**Title:** MATERIALS & METALLURGY SUBCOMMITTEE  
MEETING (ACRS)

**Date:** Thursday, November 16, 2000

7 CALCULATION OF NEUTRON FLUENCE DG-1053

FIGURE 4

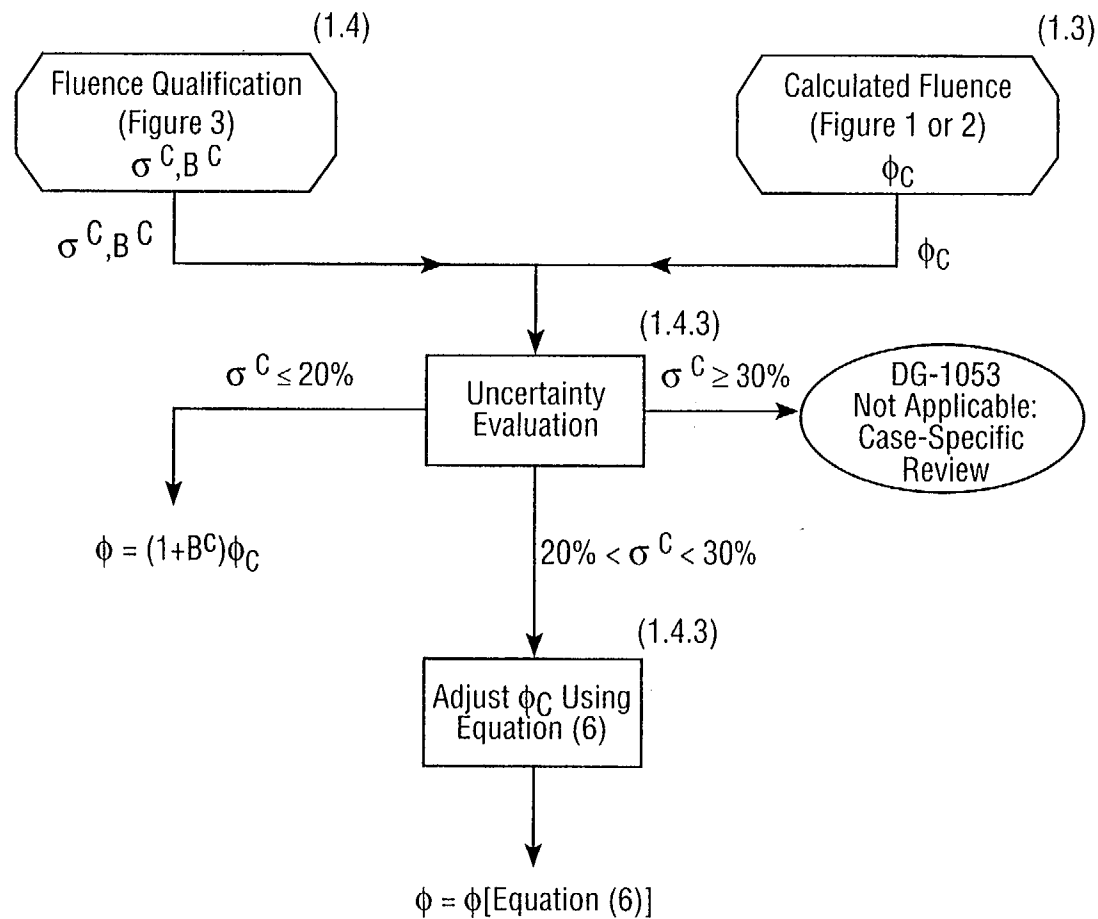
8           DR. CAREW: Okay. I have one more comment, and  
9   this was the comment from Bechtel Power, Bill Hopkins. And  
10   his comment was that he suggested the attached figure should  
11   be included in the guide to clarify the dependence of the  
12   fluence determination on fluence uncertainty. And we  
13   thought that was a good suggestion and we have incorporated  
14   that figure as Figure 4 in the guide.

<b>Comments</b>	<b>Responses</b>
2) <u>Comment:</u> The attached figure should be included in the Guide to clarify the dependence of the fluence determination on the fluence uncertainty.	2) <u>Response:</u> The proposed figure provides a significant clarification of the procedure used to determine the fluence and will be included (as Figure-4) in the Guide.
